Subject: Proposed Modification to the Davis-Besse Nuclear Power Station Operating License NPF-3, Appendix A Technical Specification (TS) 3/4.4.5, Steam Generators, to Modify Single Repair Roll Requirements and Allow the Use of the Double Repair Roll Process for Steam Generator Tubes Within the Upper Tubesheet (LAR No. 99-0001; TAC No. MA7829)

DAVIS-BESSE NUCLEAR POWER STATION

SAFETY ASSESSMENT AND SIGNIFICANT HAZARDS CONSIDERATION FOR LICENSE AMENDMENT REQUEST NO. 99-0001

Figure
Tube Repair Rolls

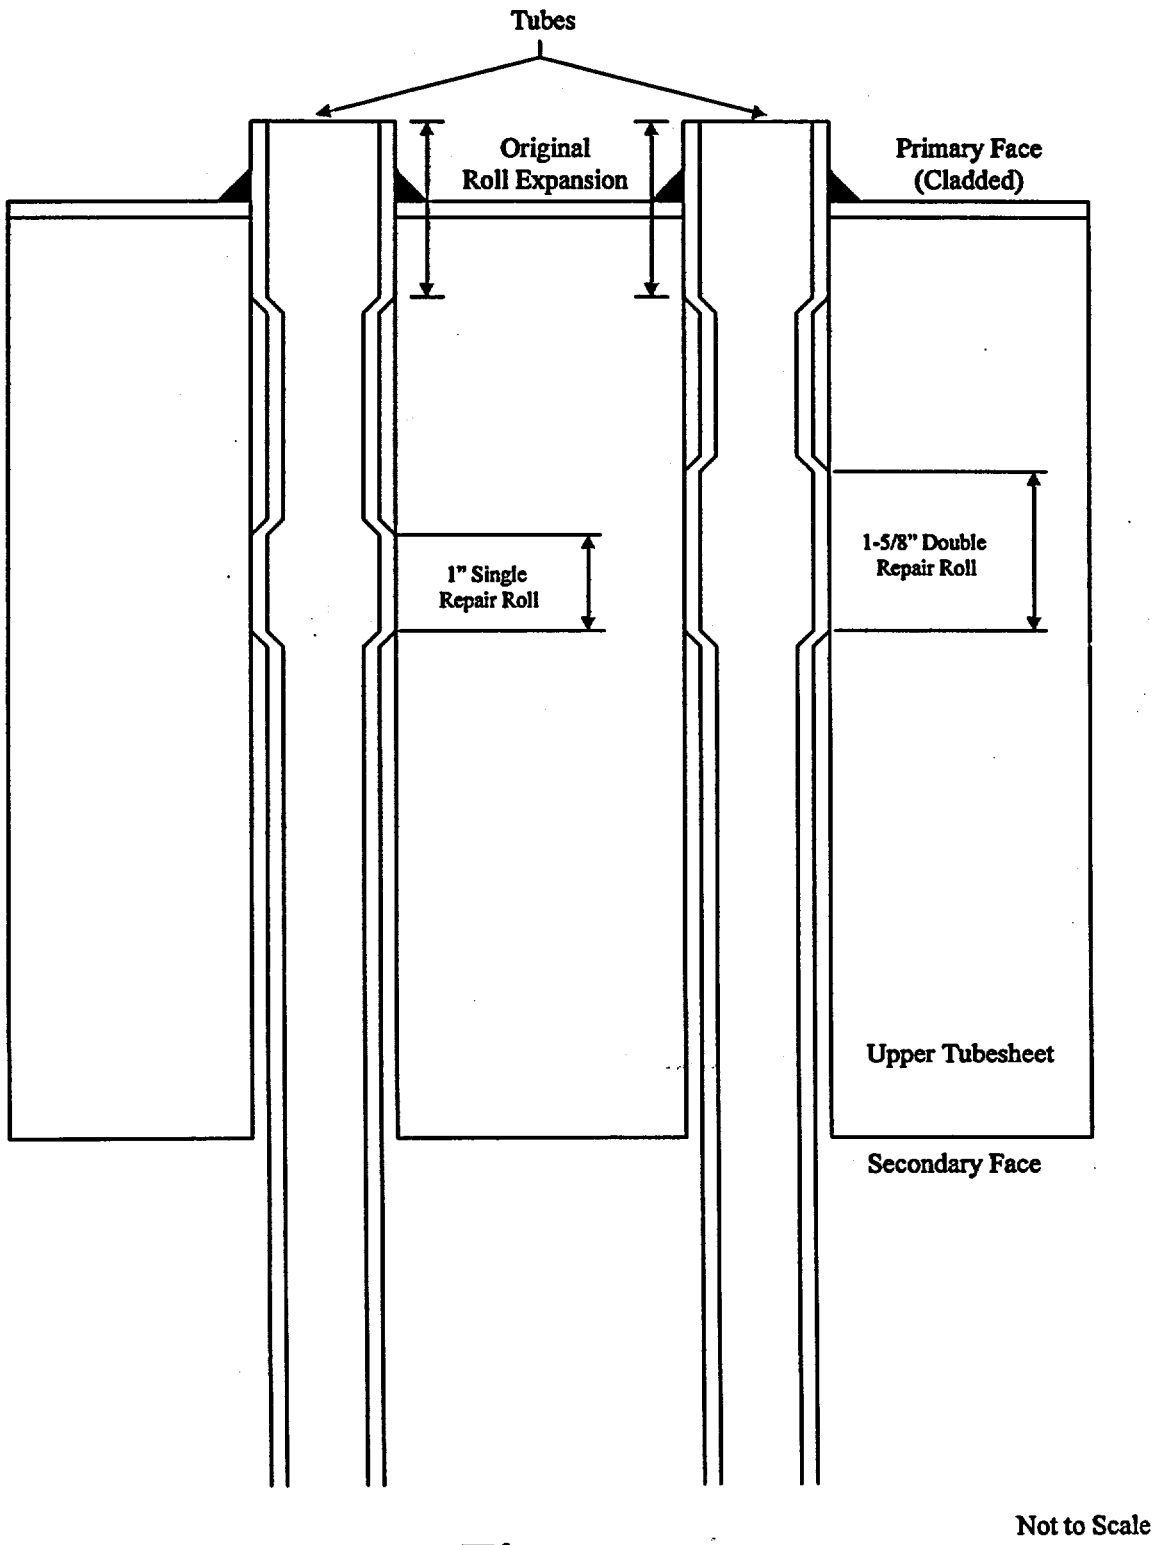
The repair roll method being modified in this LAR provides a method of repair for steam generator tubes that have sustained degradation of the tube within the steam generator upper tubesheet. The repair roll is a process whereby a new primary to secondary pressure boundary joint is established by hard rerolling the tube closer to the secondary face of the tubesheet. The new pressure boundary joint is established to remove the area of degradation from pressure boundary service (see the attached figure).
